COMMENTS OF THE COUNCIL OF INDUSTRIAL BOILER OWNERS
on
EPA Proposed Rule
*National Emission Standards for Hazardous Air Pollutants for Area Sources: Industrial,
Commercial, and Institutional Boilers*
75 Fed. Reg. 31896, EPA-HQ-OAR-2006-0790
August 20, 2010

Filed by:
Robert D. Bessette
President

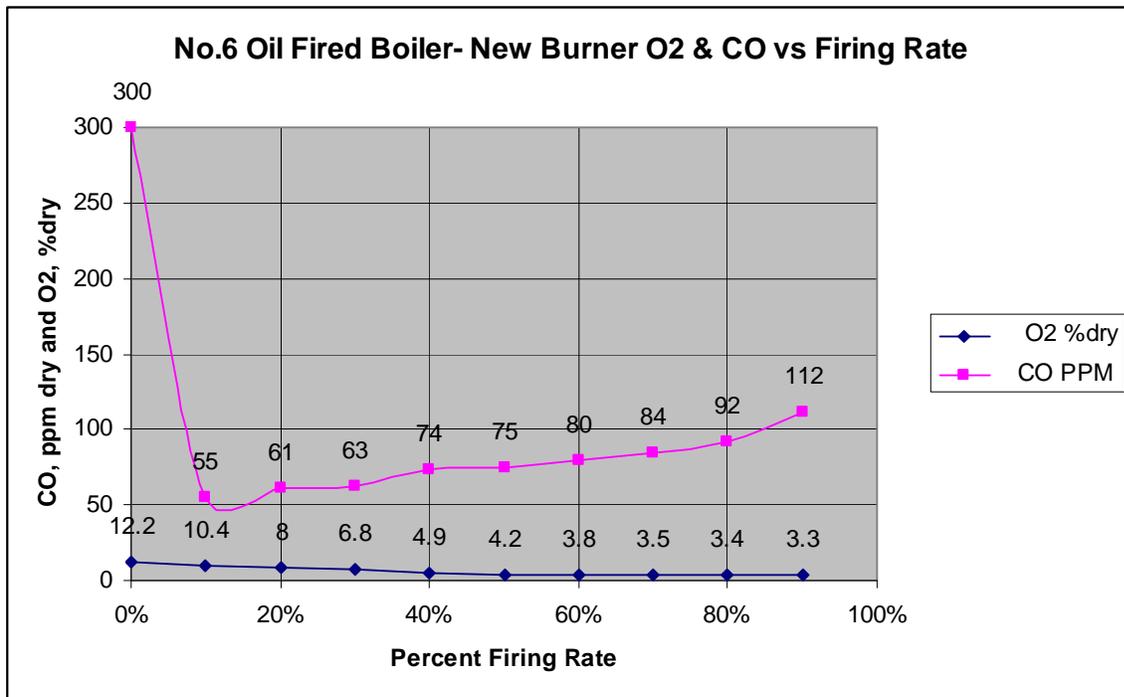
EPA has proposed to rely on CO as a surrogate for organic HAP emissions at area sources. This approach is inappropriate because there is a lack of data and EPA has not demonstrated a correlation between HAP emissions and CO levels below 100 ppm when combusting liquid fuels. CIBO recommends that EPA revisit its floor setting methodology and demonstrate that the proposed CO emissions standard is generally achievable by liquid-fired units. Additionally, EPA's overall approach with regard to the use of CO as a surrogate for organic HAP focuses on continued minimization of CO emissions; however, EPA ignores the fact that lowering CO emissions for many units will result in an increase of NOx emissions and a decrease in efficiency.
